Sunwood Development Corporation Sand and Gravel Mining Special Permit

Hamden, Connecticut

Environmental Review Team Report

Report #339

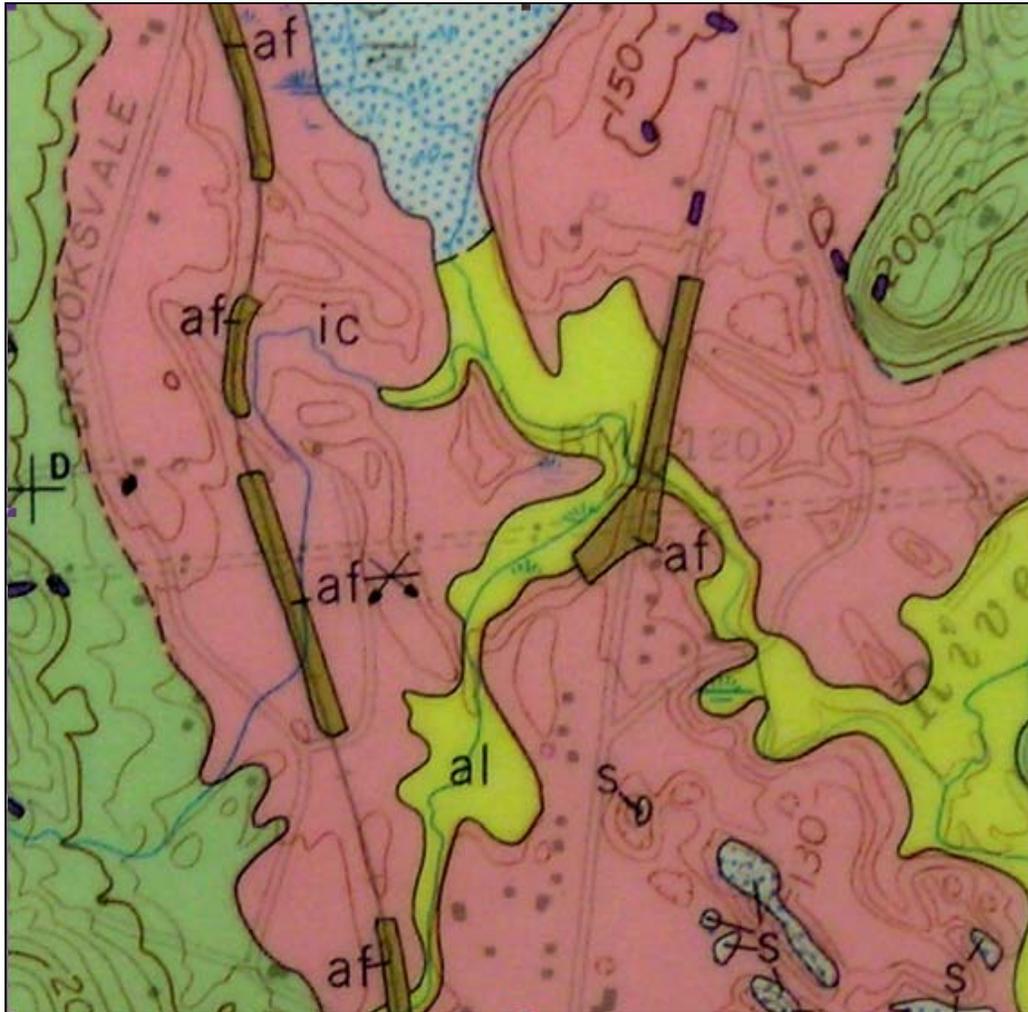
This reviewer has some concerns about the data upon which the plan was drawn. The most serious deficiency in this reviewer's opinion is the lack of subsurface data, such as the elevation of the water table and depth of bedrock. Both will have implications on how much material can be removed during the excavation. The "deep excavation" will be made by a large back-hoe like machine that has a working depth dependant on the length of the excavation arm. If the excavation proceeds (as was presented to the ERT at the field visit) by first removing material to the depth of the water table and then removing deeper material from the surface so created, the lowest (deepest) elevation to which excavation can take place will be higher if the elevation of the water table is higher than expected. This will result in less material being excavated and less profit to the developer. He may then request to pump seepage-water out of the excavation pit so as to dig deeper.

A similar end-result would occur if the depth to bedrock is shallower than the planned excavation depth. Sand and gravel deposits are not unlimited in depth and bedrock will be encountered at some depth. The developers should have access to some information (such as depth of the well on their property and adjacent properties) that would tell them that adequate sand and gravel is present, but instead seem to take it on faith that bedrock is deeper than an elevation of 91 feet. If it is not, they will not be able to excavate as much material without enlarging the area of removal. That will translate into creating

Fortunately, Mazzaferro (1973) provides relevant data from water-wells near the site that indicate the bedrock surface under the proposed gravel excavation site has an elevation of sea-level or lower (deeper). Haeni (1974) used Mazzaferro's data to provide a generalized regional map of the depth to bedrock.
